RECEIPT DATE: 2/5/18 **ONSITE SEWAGE DISPOSAL SYSTEM**

PROPERTY ADDRESS: 17741 Hardy Road

SUBDIVISION: Woodcamp Farms LOT: 25 TAX ID: 04-354605

ON SITE SEWAGE DISPOSAL SYSTEM DESIGN PLAN

ON SITE SEWAGE DISPOSAL SYSTEM DESIGN PLAN
 17741 HARDY ROAD
 LOT 25
 WOODCAMP FARMS
 PLAT NO. 23676

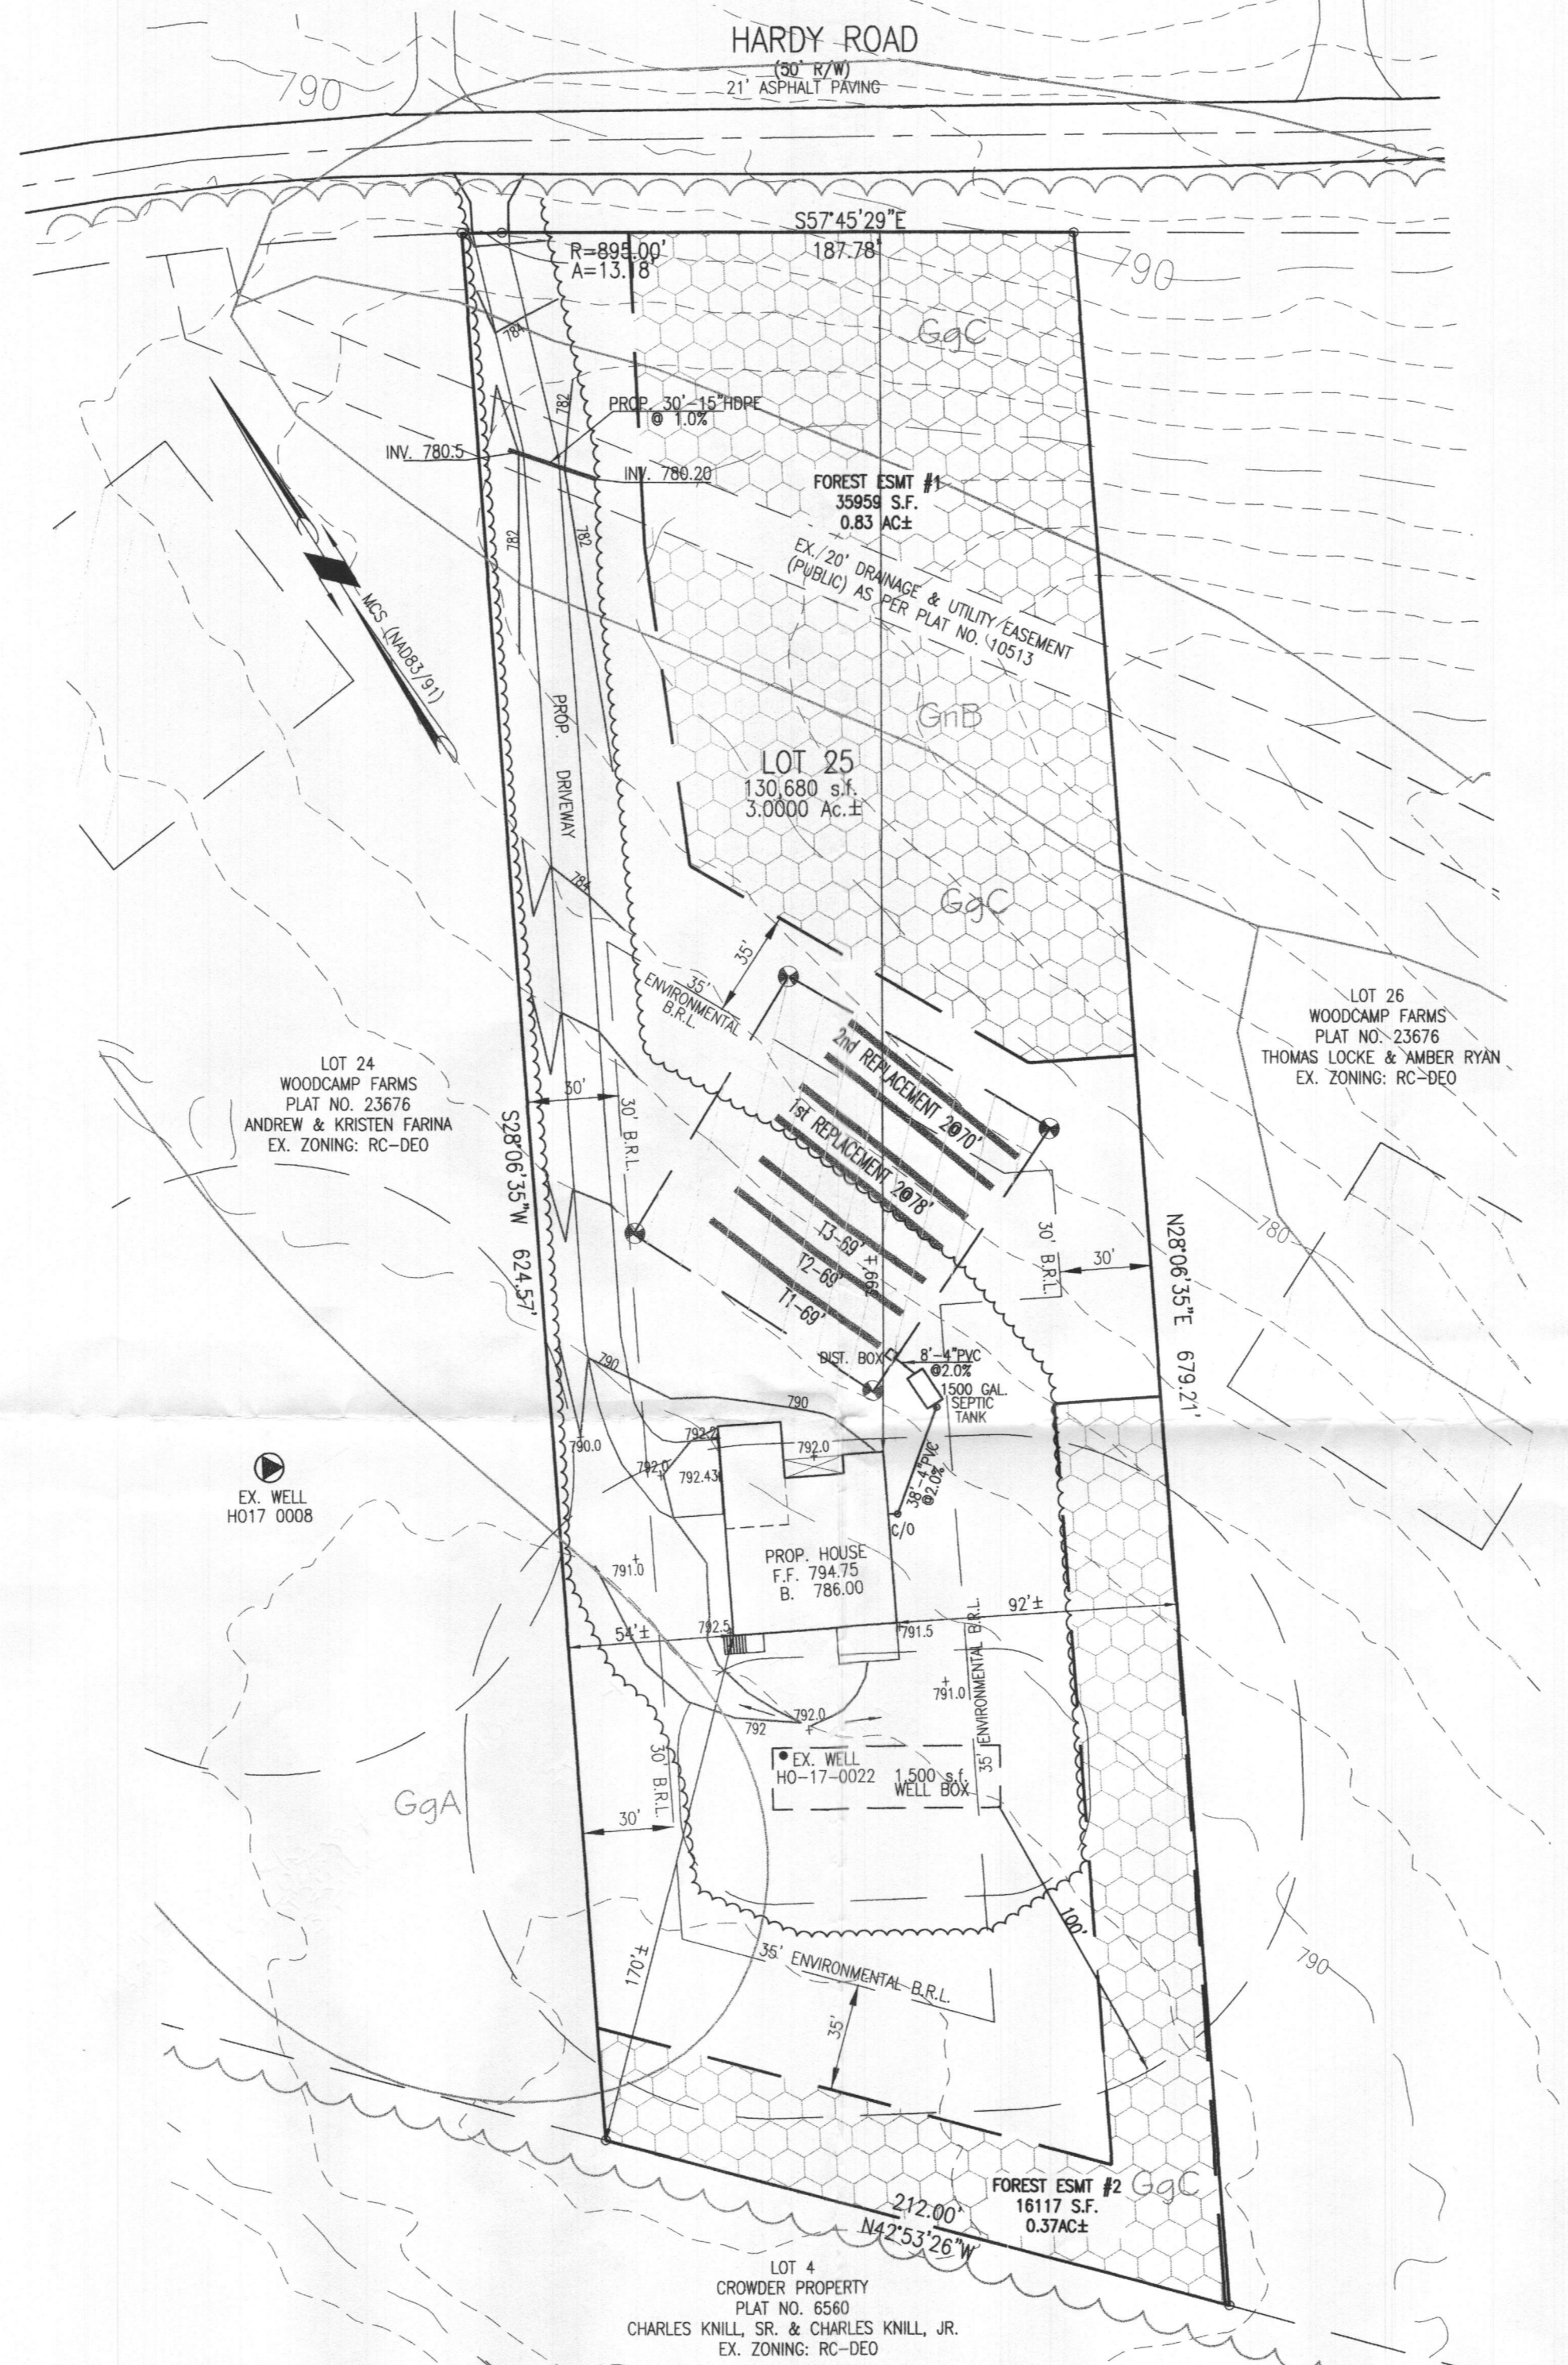
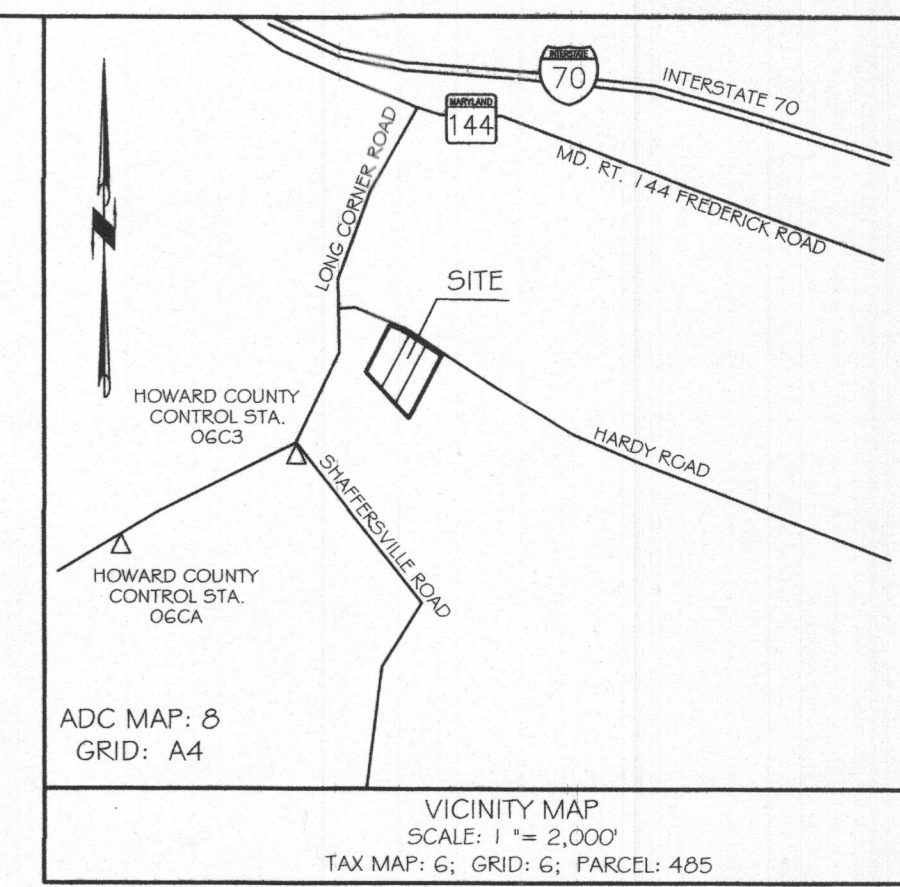
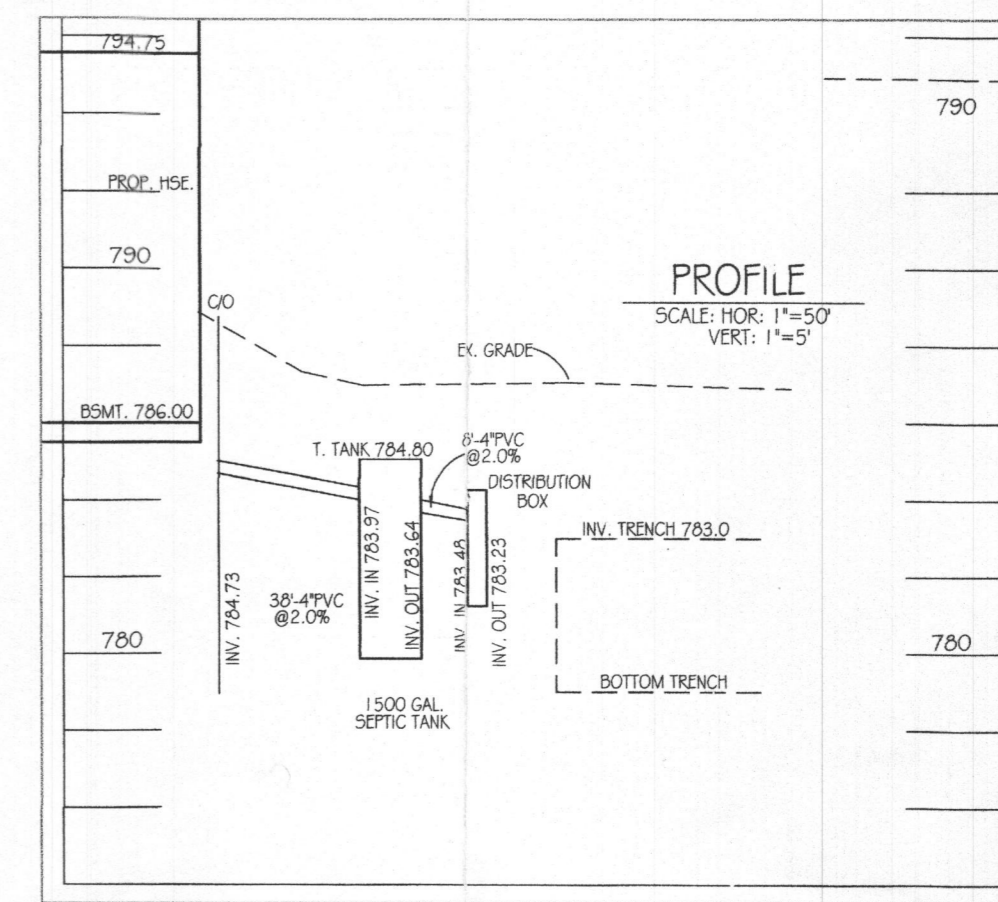
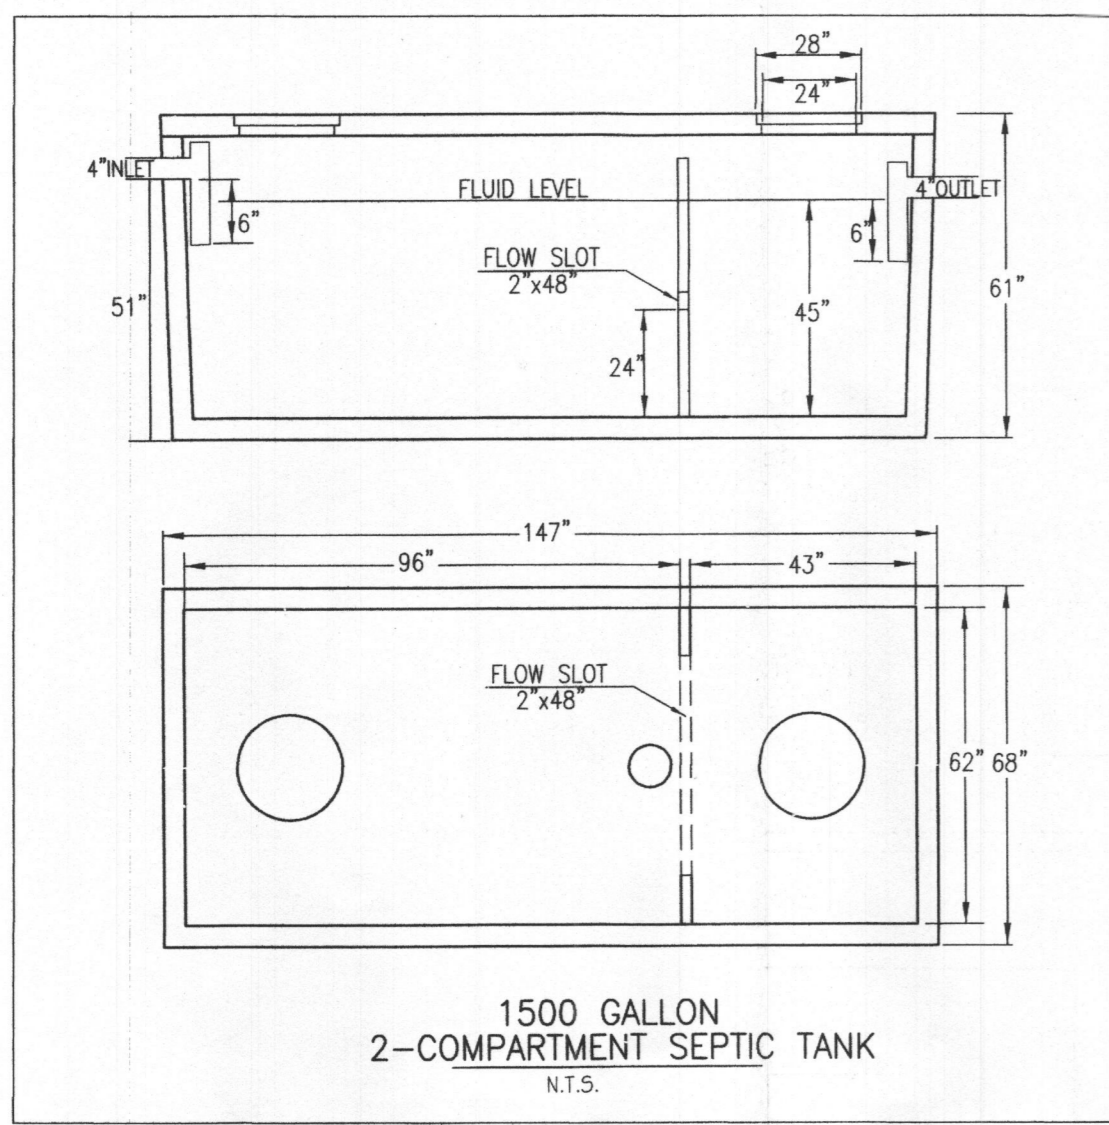
Good morning. The revised OSDS Plan shows the basement stairwell closer than 30 feet to the well box/well. Is there any way to shift the house so the setback can be met? This office will not grant a variance to the setback requirement for new house construction.

REMARKS: Hi Hank, plan revised to reflect basement entrance. Thank you!

1. The septic tank location has been revised to be 20-feet from the house.
2. The home owner will be eliminating a wall in the basement to eliminate a future bedroom in the basement. Therefore, the septic system remains a 4-bedroom system.
3. The covered porch will be on footers and will not be part of the wall check.
